COMMISSION REGULATION (EU) 20-16/---1447 of ...26 August 2016

establishing a network code on requirements for grid connection of high voltage direct current systems, and direct current-asynchronously connected power park modules, asynchronously connected demand facilities, asynchronously connected power-to-gas demand units and asynchronously connected electricity storage modules

Figure X-a: The frequency ride through profile that an HVDC system should remain connected to the network for the case of over-frequency. The value ta and tb shall be specified by the relevant TSO, but longer than for A-PPMs according to <u>Article 39</u>.

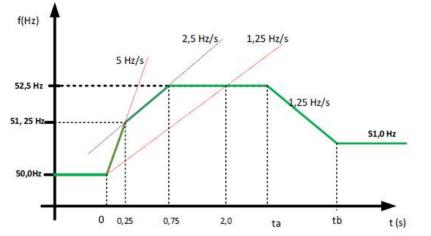
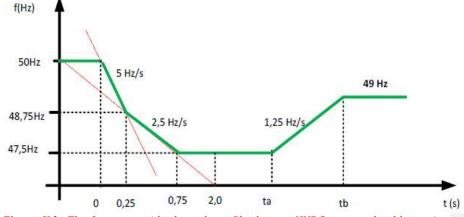
With regard to the rate-of-change-of-frequency withstand capability at the connection point:An HVDC system shall be capable of staying connected to the network and operable if the network frequency changes at a rate between – 2,5 and + 2,5 Hz/s (measured at any point in time as an average of the rate of change of frequency for the previous 1 s).

(a) an HVDC system shall be capable of staying connected to the network and operate at rate-of-change-of-frequency up to the following values (non-consecutive):
 ±5,0 Hz/s over a period of 0,25 s

±1,25 Hz/s over a period of 2 s

(b) without prejudice to the frequency ranges specified in Annex VI. an HVDC system shall be capable of staying connected to the network and operate at the sequence of rate-ofchange-of-frequencies which are defined considering the over frequency against time profiles given in Figure X-a and the underfrequency against time profiles given in Figure X-b: **Commented [MN19]:** Why are we relaxing this requirement? 250mS was avoided due to the ramp rate of this. 1.25Hz for 2 secs makes no sense, if we are talking over 1.25Hz/Sec that is 2.5Hz in 2 seconds, it will dominate, the other time scales are not needed.

Figure X-c: LFSM-UC curve for a power-to-gas demand unit

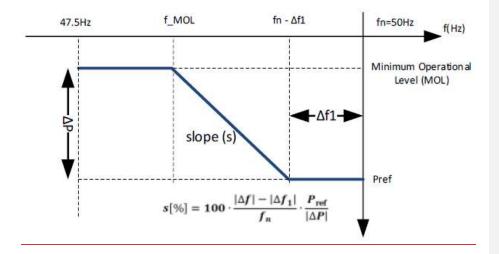
7-8. A capability for limited frequency sensitive mode — underfrequency consumption (LFSM-UC) for an asynchronously connected power-to-gas demand unit shall be based either on the measured frequency at the power-to-gas demand unit interface point or shall be based on a fast signal response as specified in paragraph 1 for the 50 Hz nominal system. More specifically, the following shall apply:

(a) the power-to-gas demand unit shall be capable of reducing the consumption from the current active power input automatically down to the minimum technical operational level, according to the indicative Figure X-c at a frequency threshold and with a droop setting specified by the relevant TSO:

Figure X-d: Fault-ride-through profile of a Power-to-Gas Demand Unit.

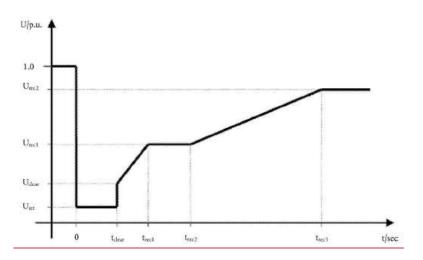
With regard to fault-ride-through capability of asynchronously connected power-to-gas demand units:

(a) the asynchronously connected power-to-gas demand unit shall, when operating above the minimum operating level, be capable of staying connected to the network and continuing to operate stably after the power system has been disturbed by faults in the isolated AC network according to a voltage-against-time-profile in line with Figure X-d and Tables X.1.1 to X.1.2.

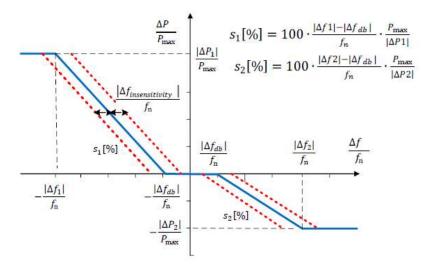
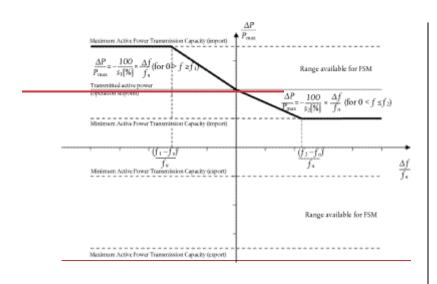
Parameters	Ranges
$\Delta f_1/f_n, \Delta f_2/f_n$	<u>0,02-0.06 %</u>
$\Delta f_{db}/f_n$	<u>0-0,01%</u>
Frequency response dDeadband of the FSM, Δf_{db}	0-±500 mHz
Range of the <code>Đd</code> roop <i>s</i> ₁ (upward regulation)	<u>≥</u> Minimum-0,1 %
Range of the <code>Đd</code> roop s ₂ (downward regulation)	<u>≥</u> Minimum 0,1 %
Frequency response insensitivity <u>, ∆f_{insensitivity}</u>	<u>≤Maximum</u> -30 mHz

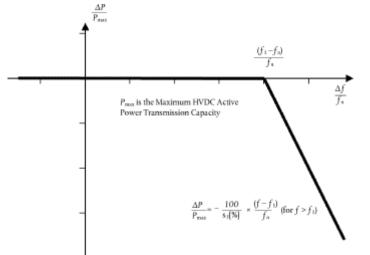
(a) the HVDC system shall be capable of adjusting active power frequency response to the AC network or networks, during both import and export, according to Figure 3 at a frequency threshold f_1 adjustable between and including 50,2 Hz and 50,5 Hz with a droop S_3 adjustable from 0,1 % upwards; the default frequency threshold f_1 shall be 50 Hz + Δf_1 , where Δf_1 is defined in Table X.

(c)(d) the HVDC system shall be capable of stable operation during LFSM-O operation. When LFSM-O is active, hierarchy of control functions shall be organised in accordance with <u>Article 35Article 35</u>.
